WITHIN
INSTRUMENT
POD

FRANK
ORIGINAL
INSTALLATION

2/14/19

CHANGES FROM ORIGINAL

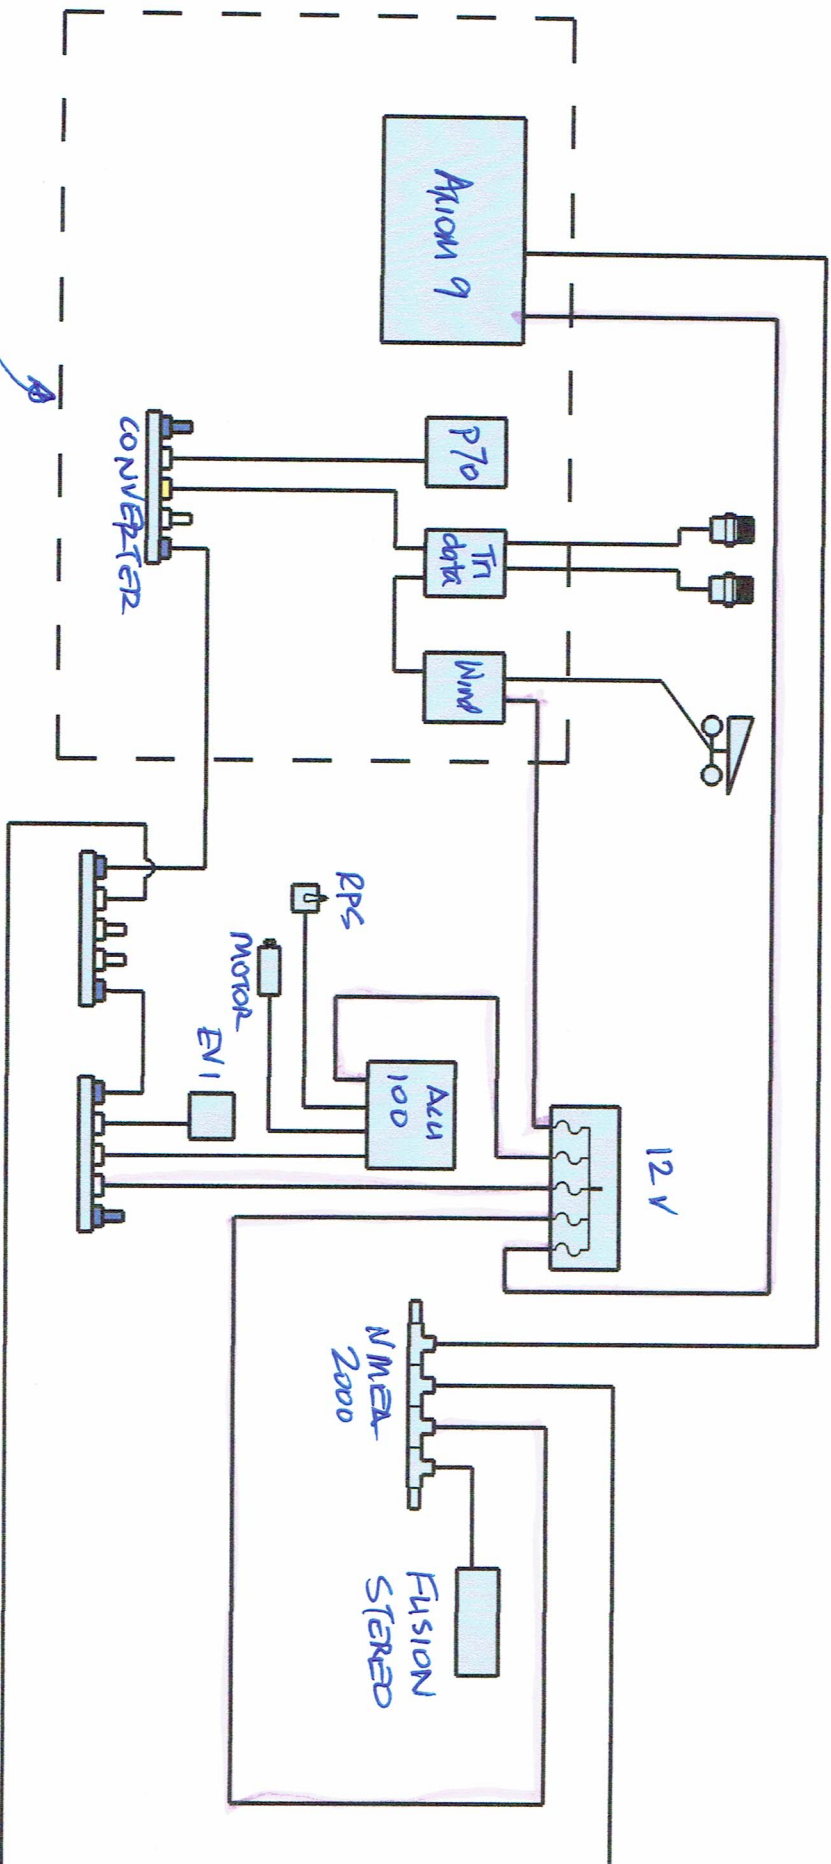
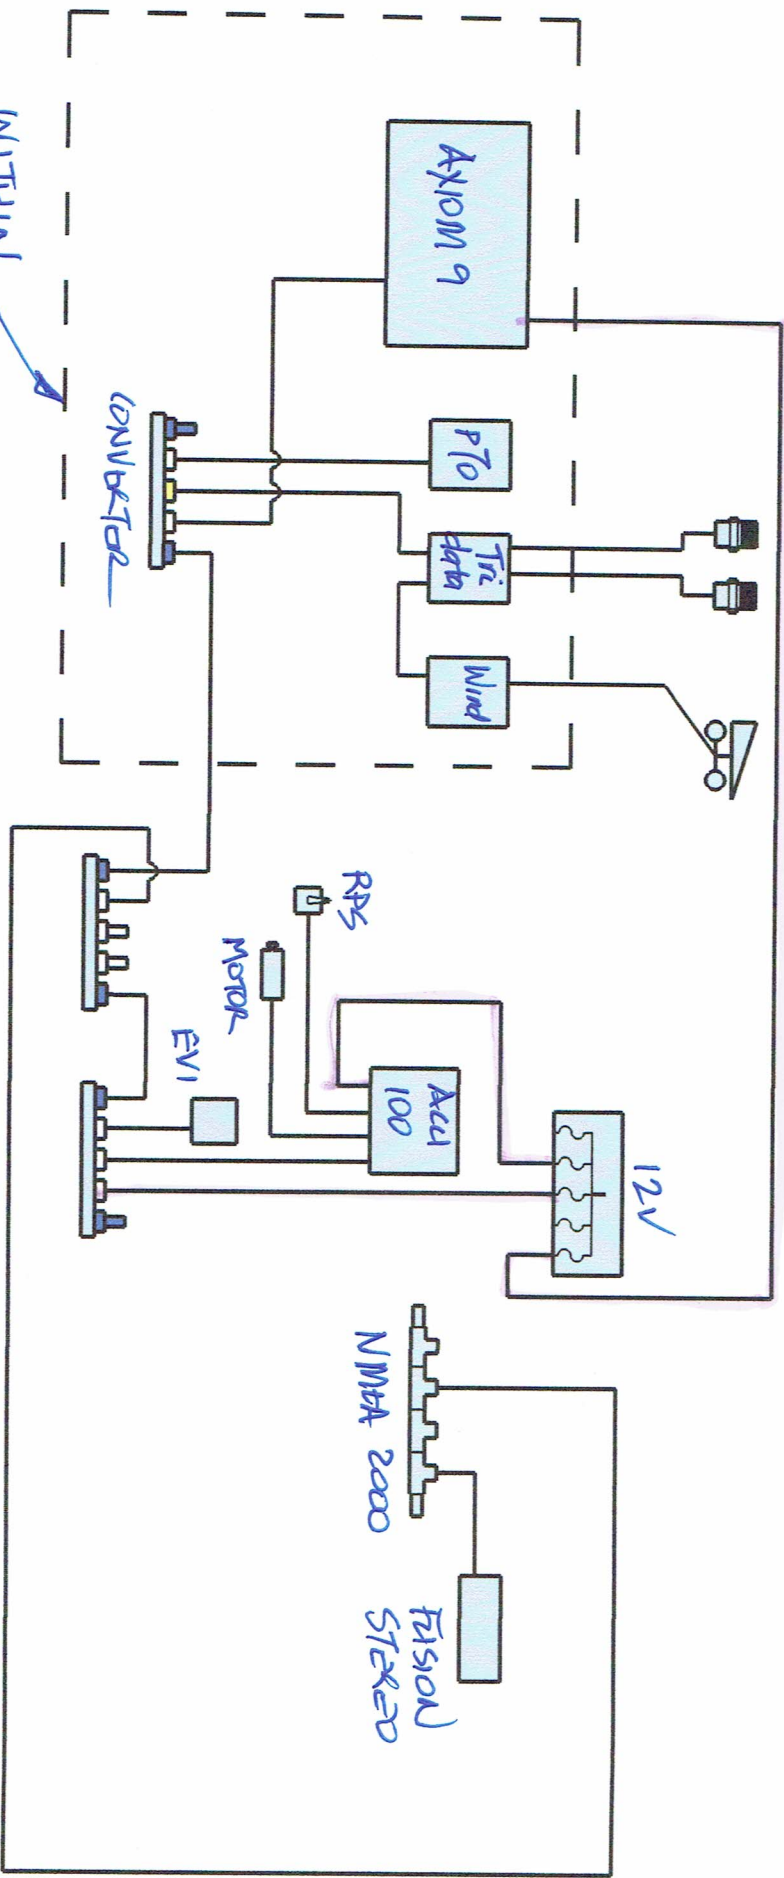
- 1) REMOVE POWER LEADS TO STROB + WIND + NMEA 2000, LEAVING POWER ONLY TO STNG
- 2) CONVERT AXIOM 9 TO STNG, RATHER THAN NMEA 2000
